Staff Report to the Weber County Planning Division

Application Request: File Number: DR 2026-08 - Request for approval of an amendment to the DR2025-12, a proposal to construct one new building and make site improvements in parking and landscaping.

**PROJECT REVISIONS
JULY 28, 2026
KEVERI BUILDINGS
2367 RULON WHITE BLVD**

Keveri Buildings 2367 Rulon White Blvd Improvement Plans

1. “PROJECT REVISIONS—SITE PLAN” DRAWING

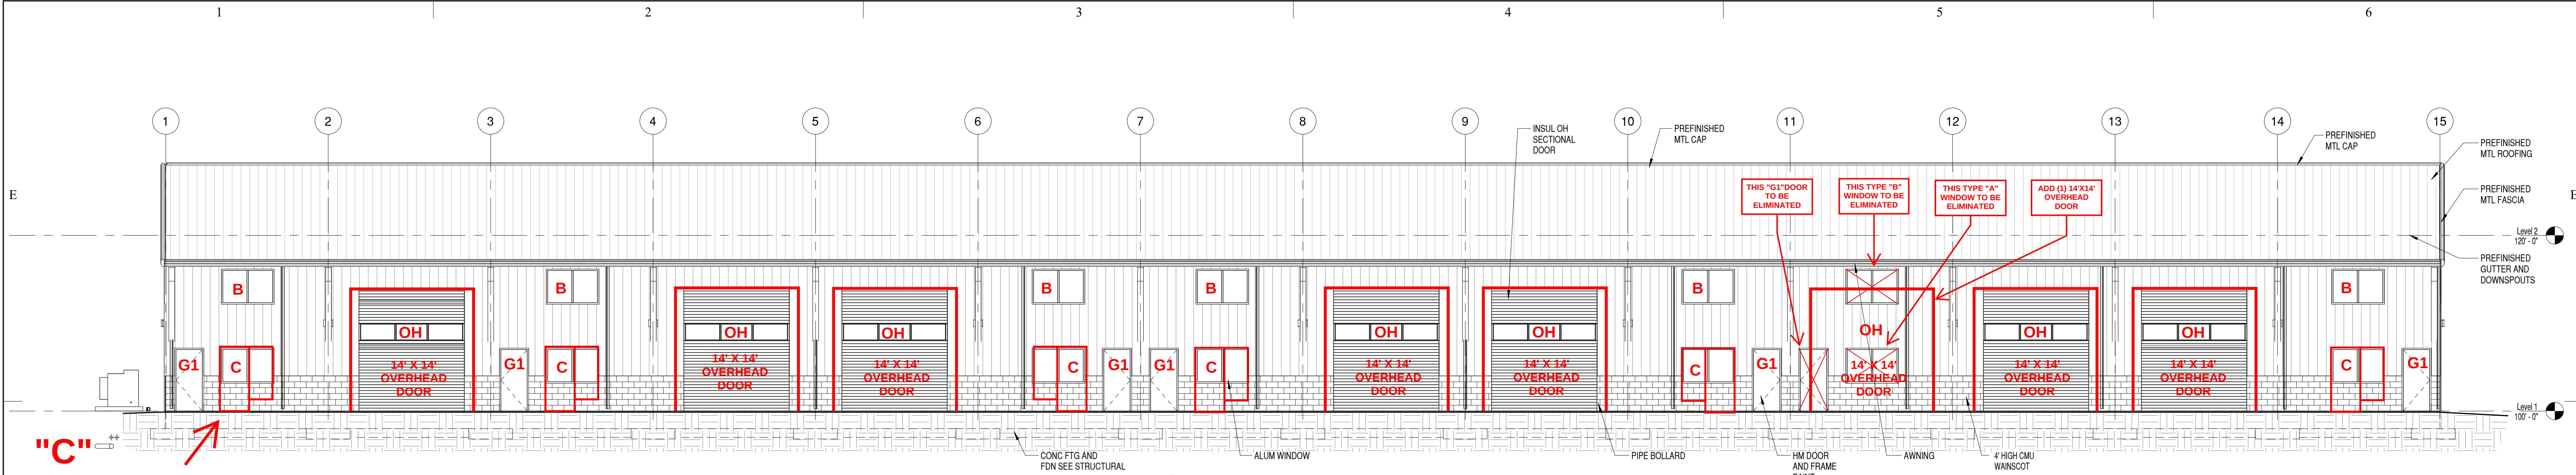
- a. The “South” building is being eliminated from the project and will not be constructed.
- b. The area where the “South” building was proposed will be paved and become part of the general parking lot area.

- i. The balance of the west area adjacent to where the “South” building would have been built will be paved and become part of the general parking lot area.

- ii. Future dumpster(s) will be located in this general area; exact size and location “TBD” contingent to future tenants.
- c. The “North” building will be enlarged by adding a 12’x259’ extension to the entire South side of the building.

- i. This will add 3,108 sf to the “North” building
 1. Total revised square footage of the “North” building will be approximately 19,563 sf.
 - ii. The area West of the “North” building to be rock mulch.

- d. Eliminate the original dumpster enclosure area and pave with asphalt as part of the general parking lot area.

2. “ELEVATION REVISIONS—NORTH BUILDING” DRAWING

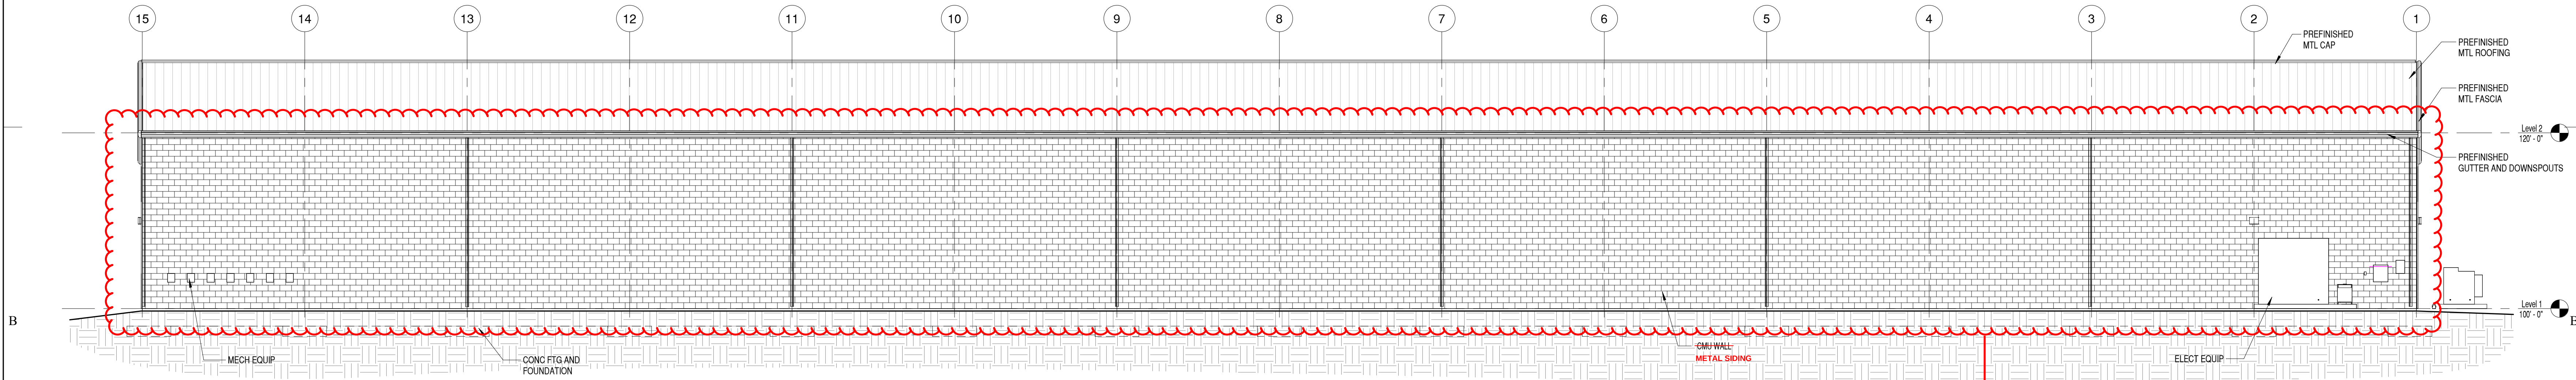
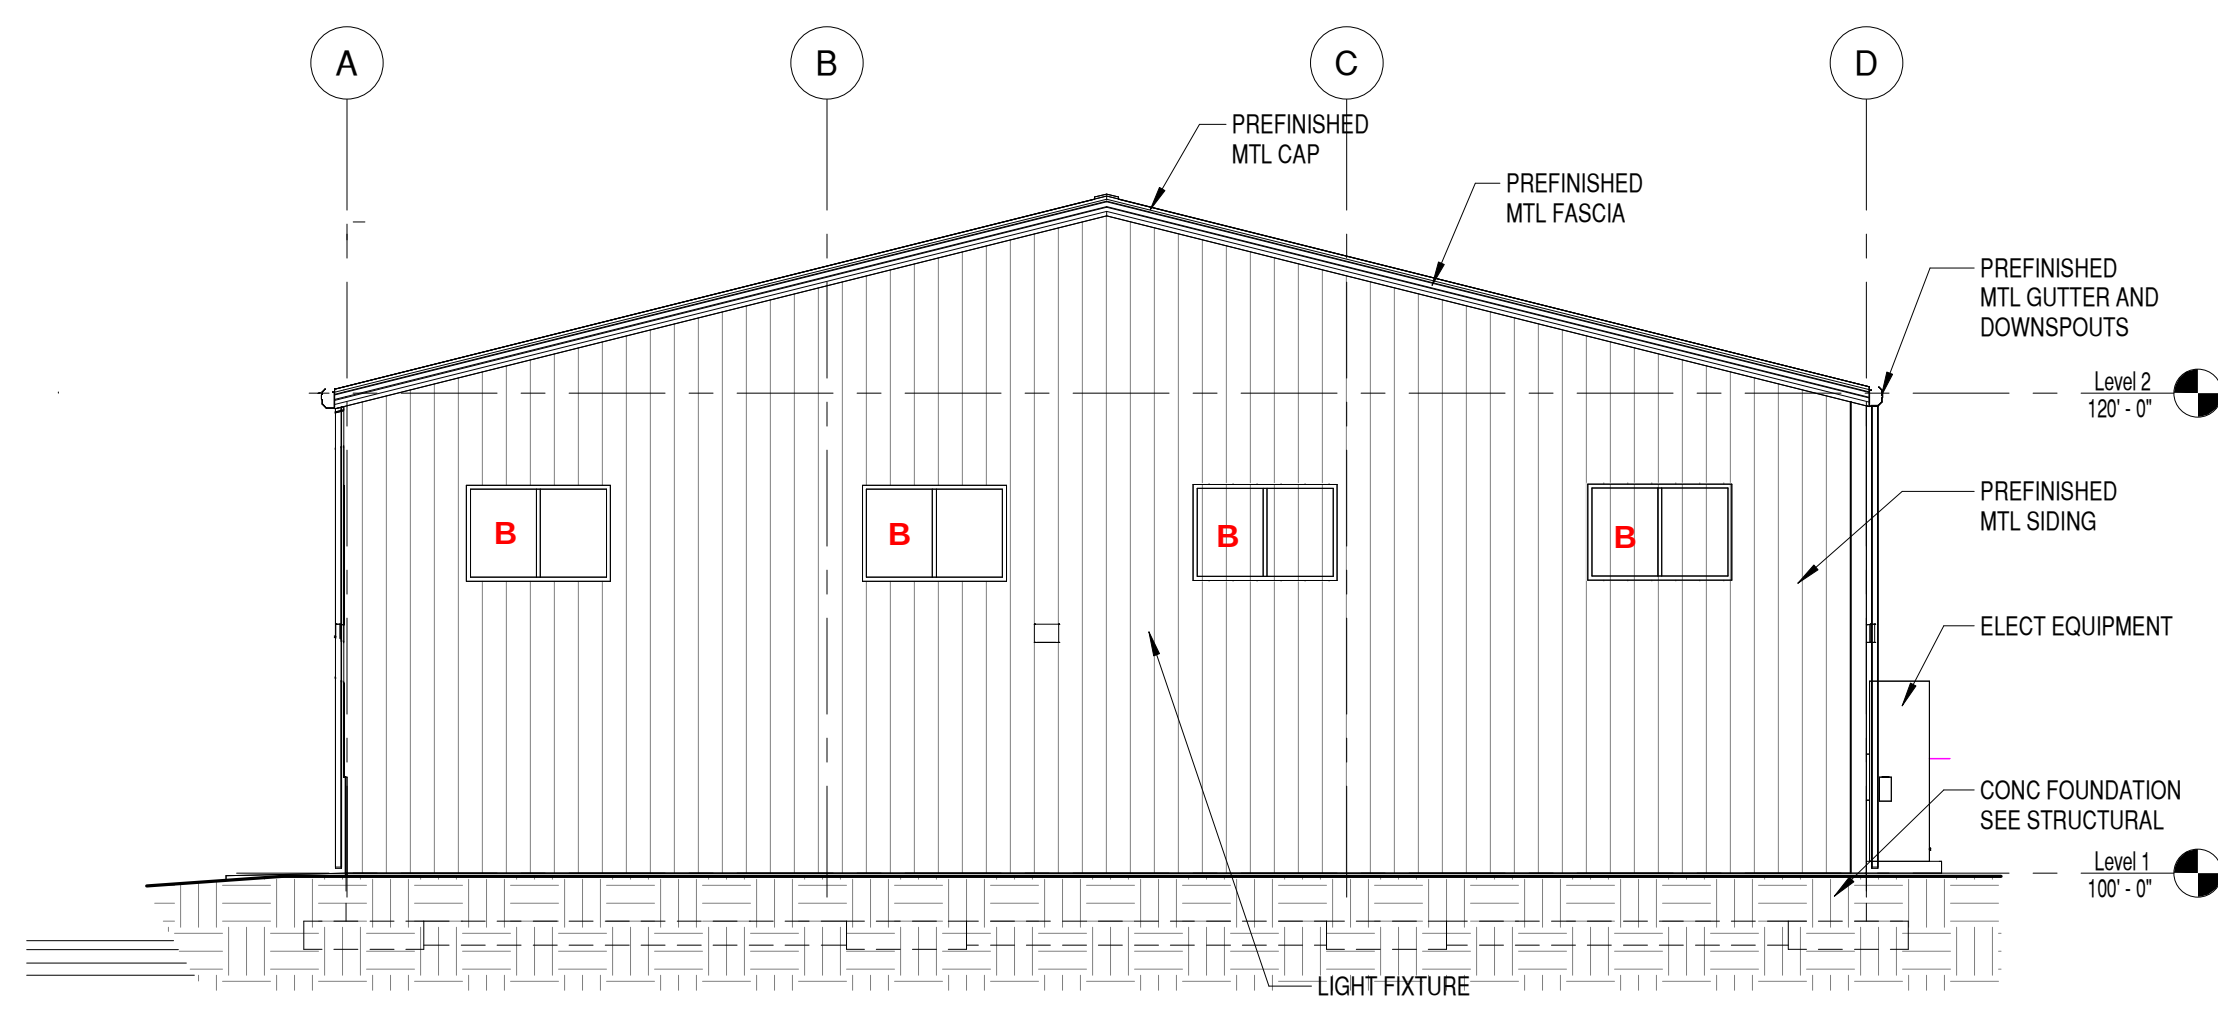
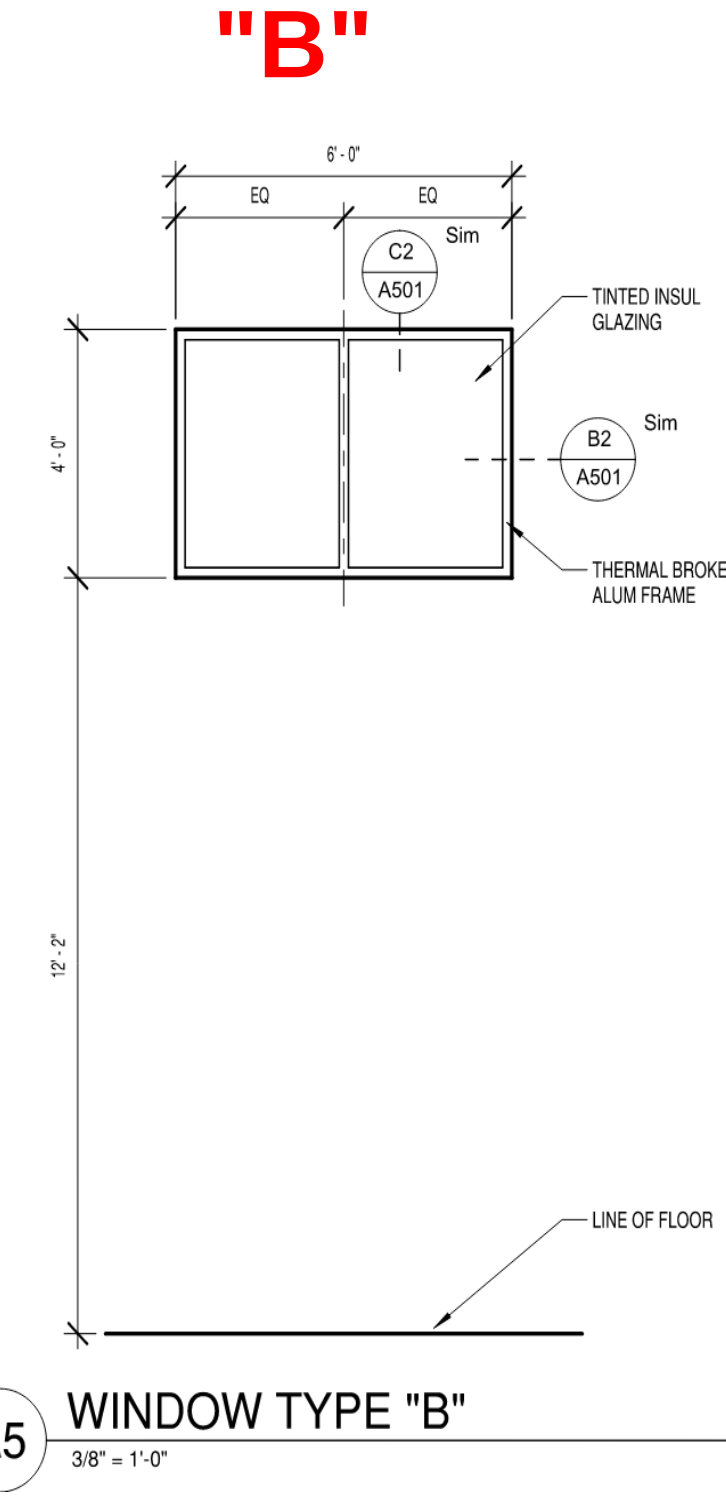
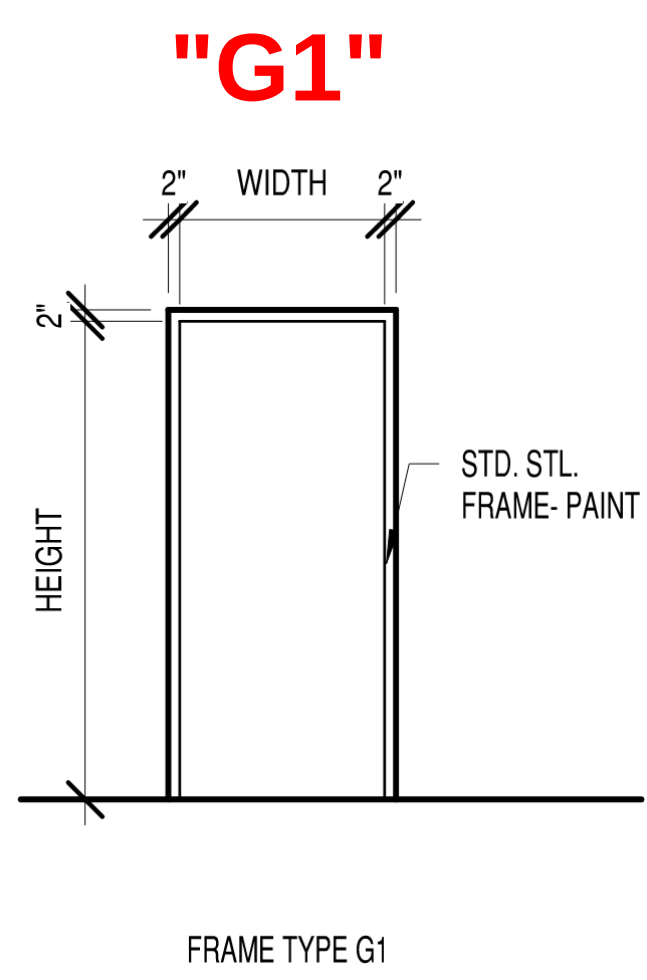
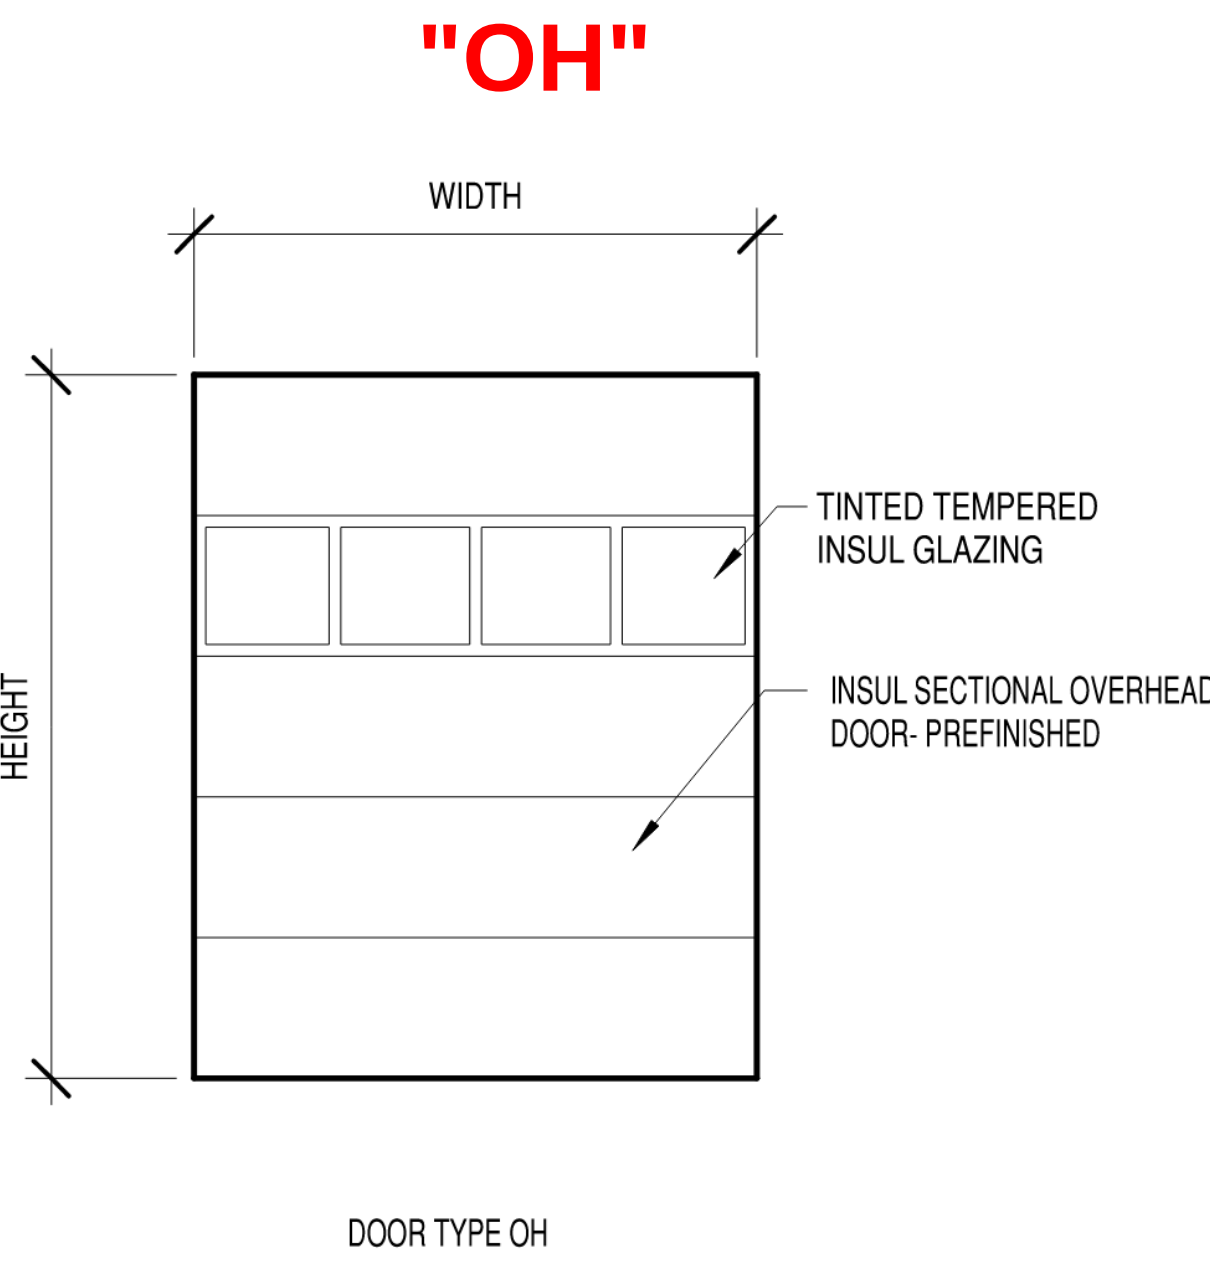
- a. Window/door revisions:
 - i. Eliminated one (1) type B window from the front elevation.
 - ii. Eliminated one (1) type A window from the front elevation.
 - iii. Eliminated one (1) 3/0x7/0 type G1 personnel door from front elevation.
 - iv. Added one (1) 14’x14’ overhead door to the front elevation.
 - v. Changed all overhead doors from 12’ width to 14’ width.
 - vi. Added six (6) type C storefront door/window combinations to the front elevation.
 - vii. Added two (2) type B windows to both the East & West elevations.
- b. Changed the rear exterior wall of the “North” building from masonry to metal siding.
